TESTIMONY BY RODERICK K. BECKER
DIRECTOR, DEPARTMENT OF BUDGET AND FINANCE
TO THE HOUSE COMMITTEES ON ENERGY AND ENVIRONMENTAL
PROTECTION AND WATER, LAND, AND HAWAIIAN AFFAIRS
ON
SENATE BILL NO. 77, S.D. 3

RELATING TO CAPITAL IMPROVEMENT PROJECTS

SUBJECT: Senate Bill No. 77 SD3, Relating to Capital Improvement Projects

Figure ES-1. USACE Rendering of 1-Percent Annual Chance Exceedance Flood

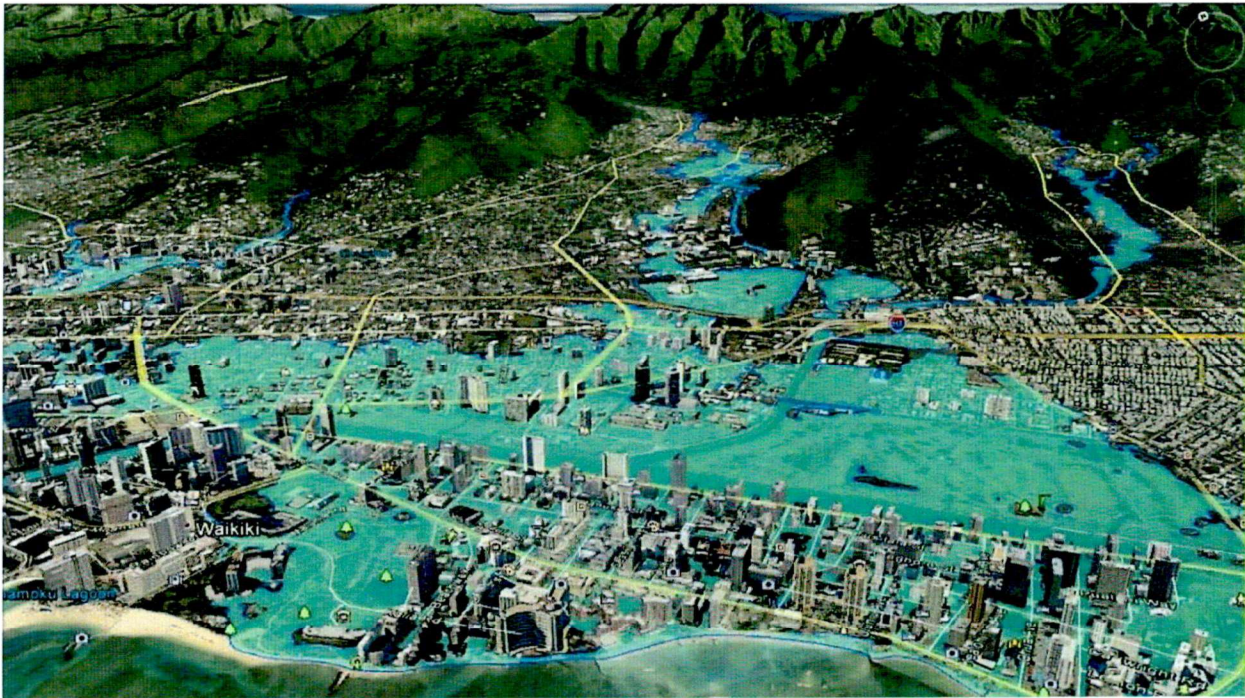
USACE and DLNR admitted
flawed and unrealistic modeling

Drawing No. 1

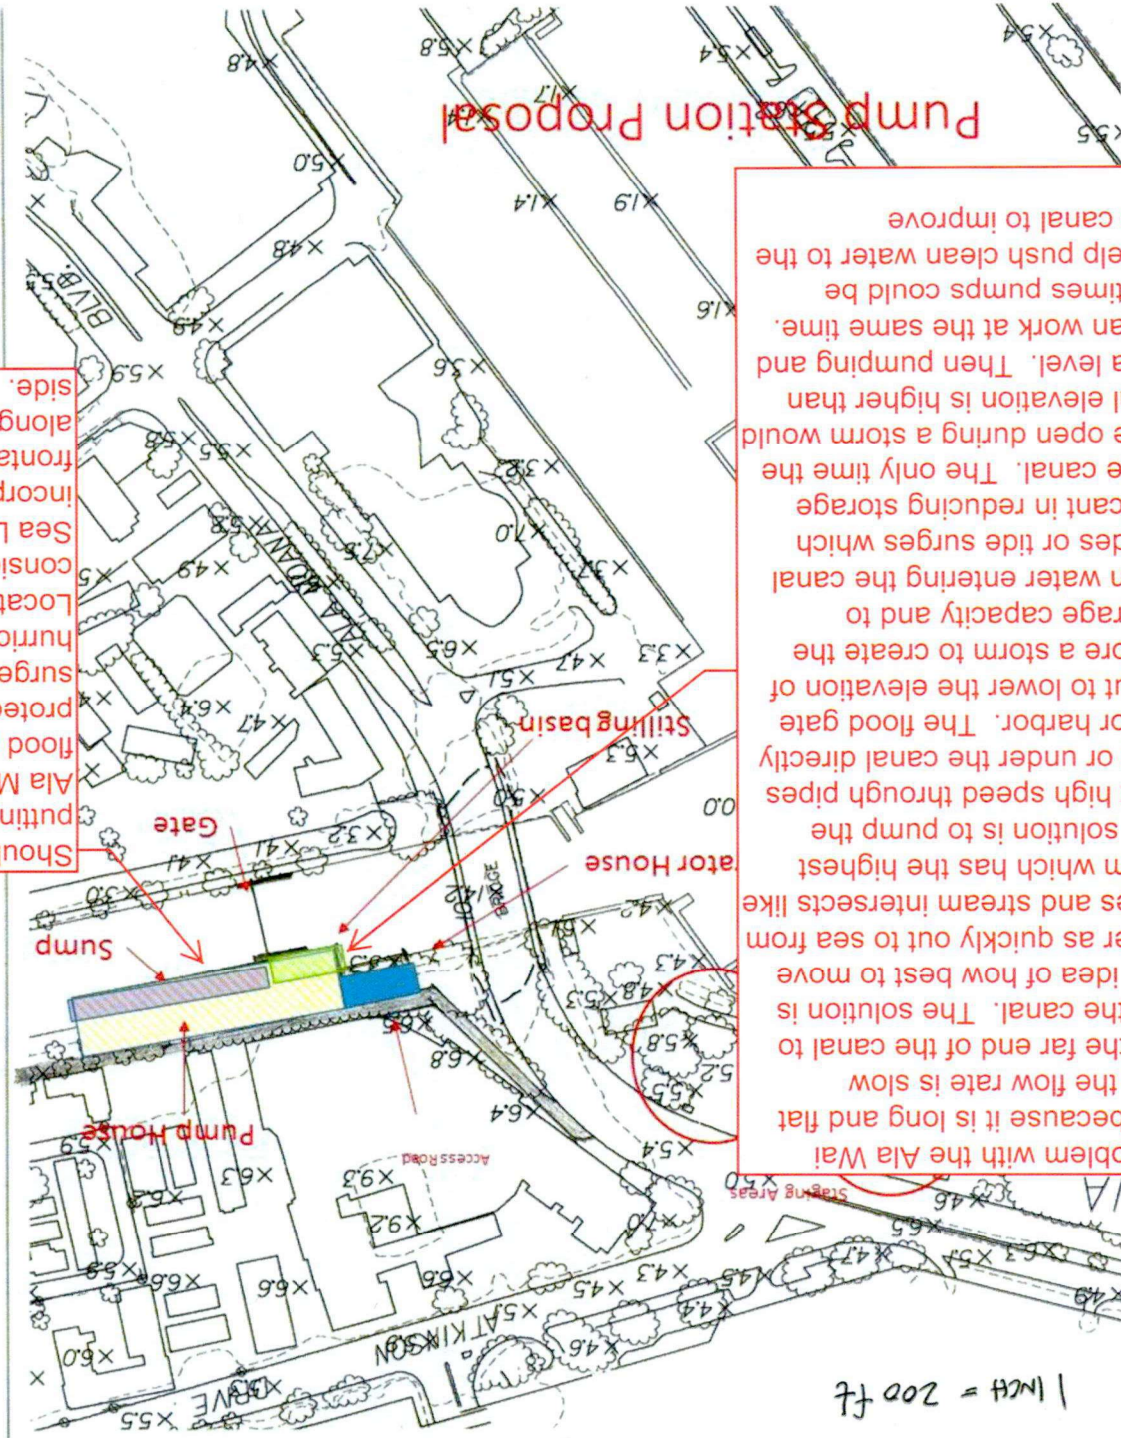
3. Gate and pump house structures to impact view-plane along canal between Ala Moana Blvd and Kalakaua Ave. ← Better locations available, split locations, near intersect, pipe to mouth

Pump set-up in HMS model

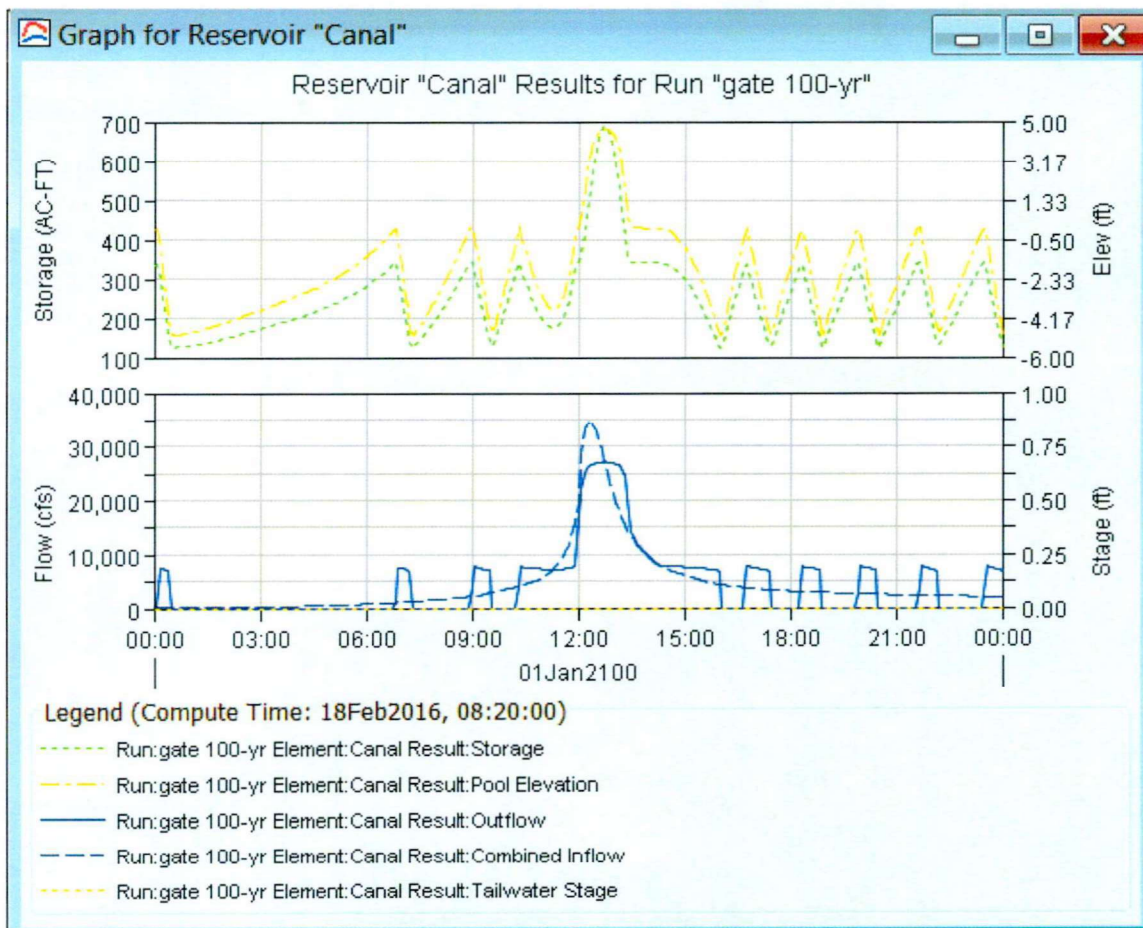
Results from pumping alone, with no gate opening during the 1% ACE flood event would result in a peak stage of 8.0 ft. Thus, pumping alone without gate control would result in the need for floodwalls along the canal to be 4 to 5 ft high on average. The same floodwall heights as in the current TSP. ← Not enough information provided to concur.
